SUBJECT: Forwards addl clarification re 811210 proposed license  
 amend re moderator temp coefficient, in response to NRC  
 820125 request.

Re: Turkey Point Unit 3 & 4  
Docket Nos. 50-250 and 50-251  
Proposed License Amendment  
Moderator Temperature Coefficient

COMPARISON OF RESULTS FOR THE  
BANK WITHDRAWAL FROM SUBCRITICAL ANALYSIS  
USING DIFFERENT MODELS

FIGURE 1: TURKEY POINT DANK WITHDRAWAL FROM SUBCRITICAL  
AVERAGE CHANNEL TRANSIENT

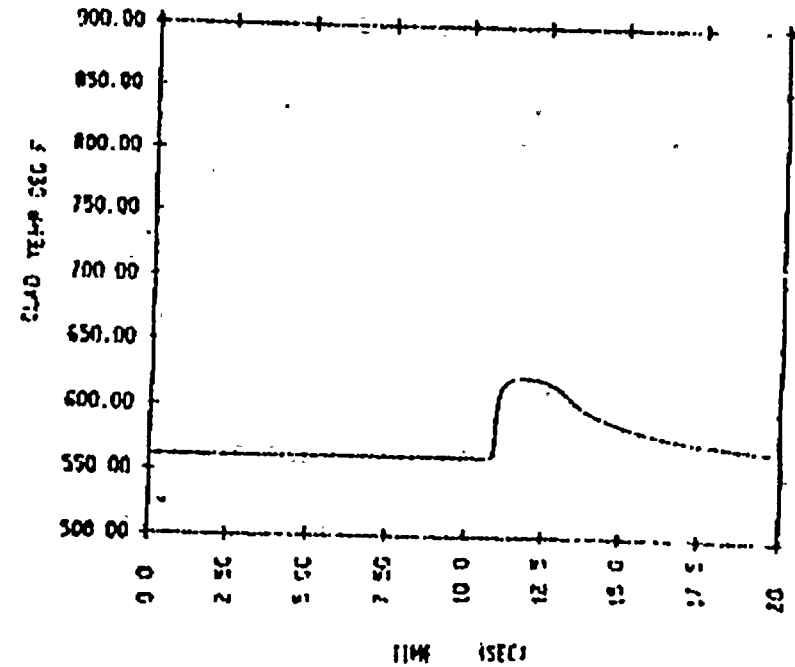
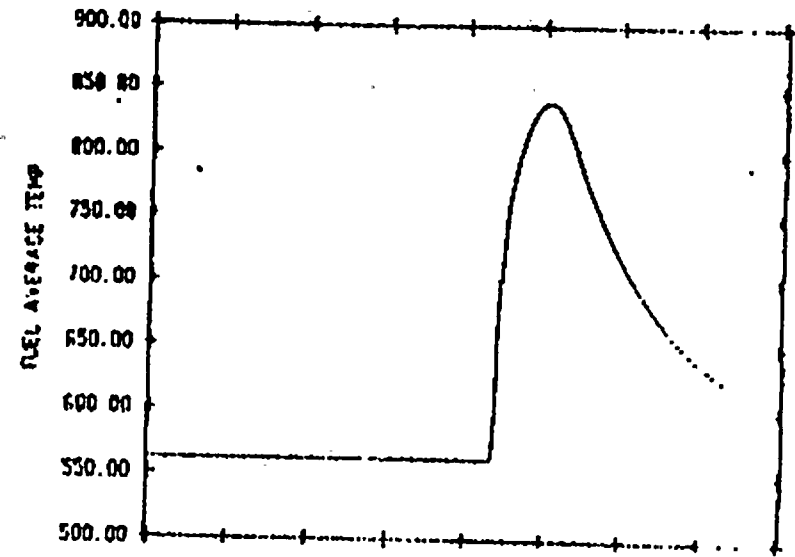
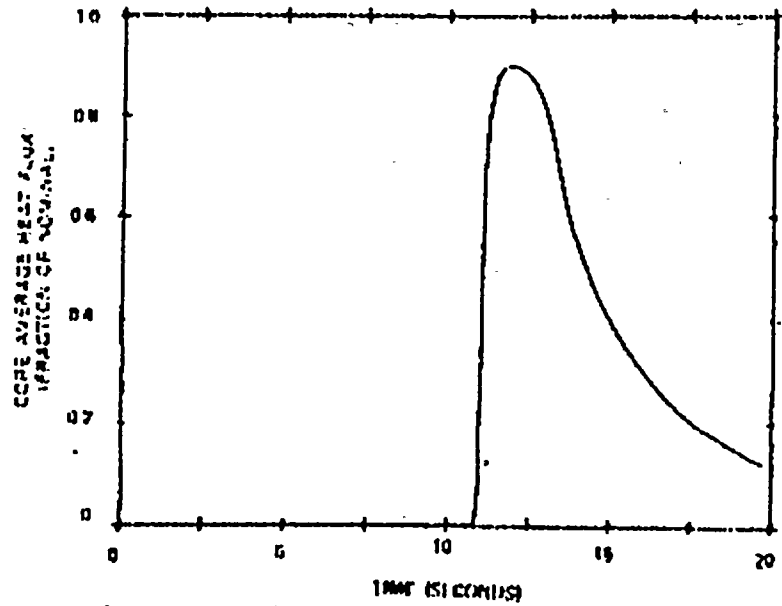
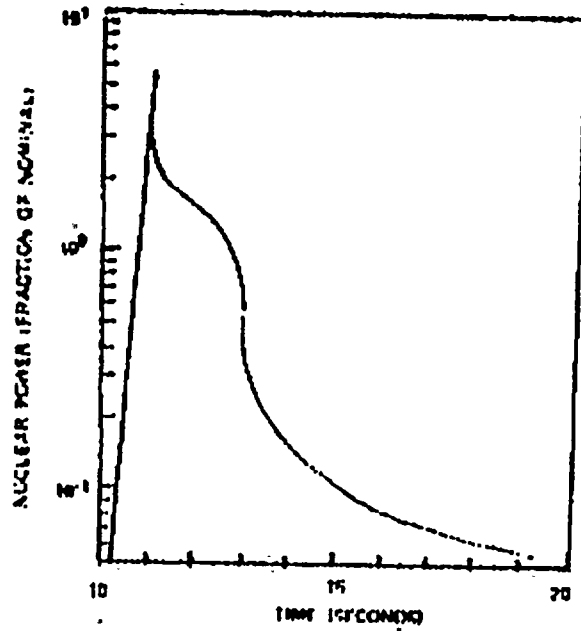
The conservatism inherent in the point kinetics model is easily seen by comparing the values in Table 1 and the transients in Figures 1 and 2. For the same reactivity insertion rate of 75 pcm/sec, the maximum nuclear power as calculated by MIT-6 is approximately six times the value calculated by THINKLE. The maximum average heat flux is more than twice the value calculated for Seabrook (.901 vs .339). The predicted fuel and clad temperatures are also higher in the Turkey Point analysis than in the other three calculations, indicating

In conclusion, the table and figures show that the point kinetics model is highly conservative since a comparable 1-D model analysis of the bank withdrawal from subcritical analysis yields acceptable results, i.e., DNBR above the limit value. Therefore, it can be concluded that the licensing basis of Turkey Point is sufficient to show that the minimum DNBR is greater than the limit value of 1.30.

FIGURE 2: SEABROOK BANK WITHDRAWAL FROM SUBCRITICAL  
AVERAGE CHANNEL TRANSIENT  
MINIMUM DNBR AT HOT SPOT = 1.59

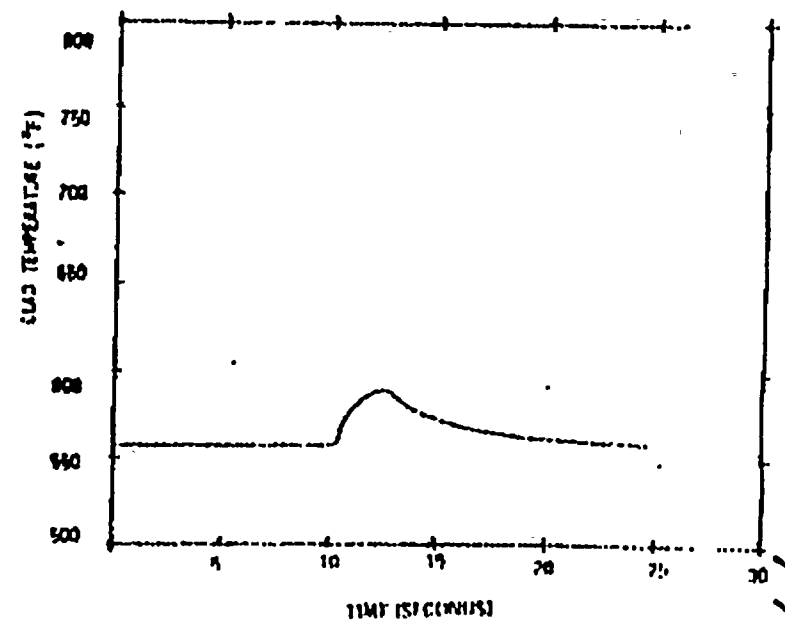
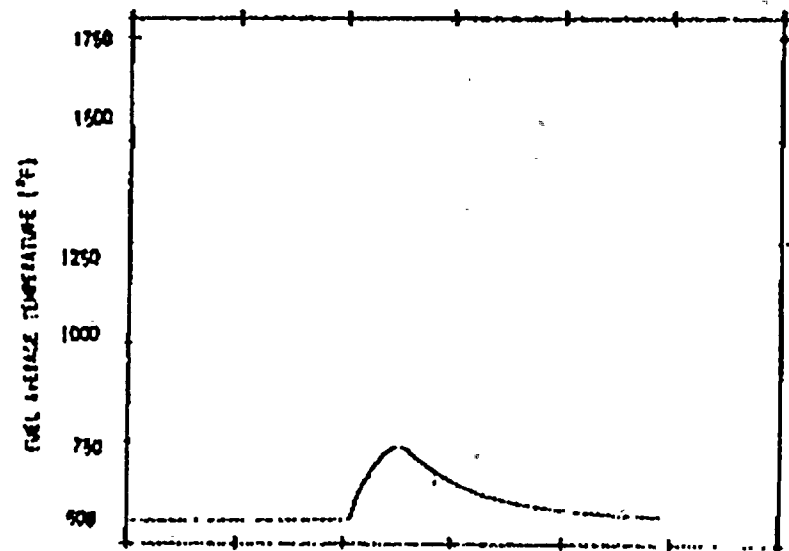
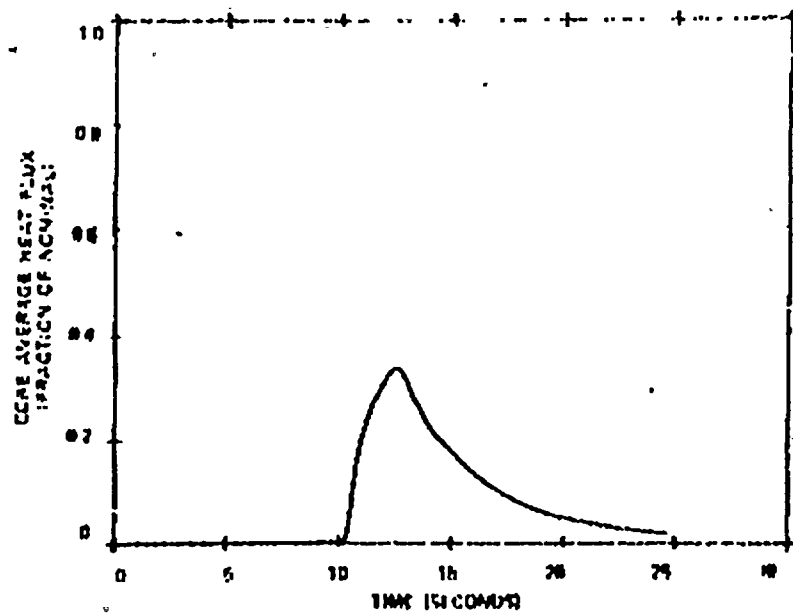
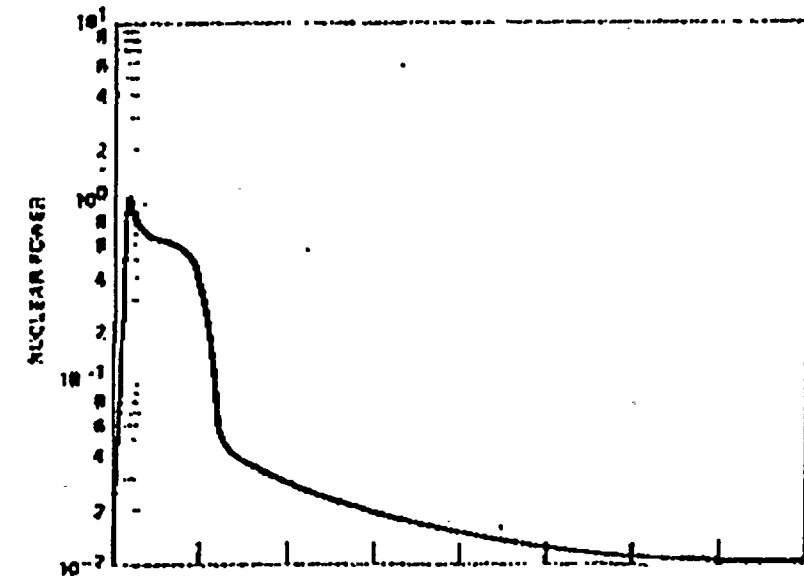
a conservatively low amount of subcooling. Thus, the Turkey Point analysis bounds the 1-D analysis for the average channel. The minimum DNBR's for all three plants presented remain above the limit values, for Seabrook, the minimum DNBR is 1.59. This is well above the limit value of 1.30.
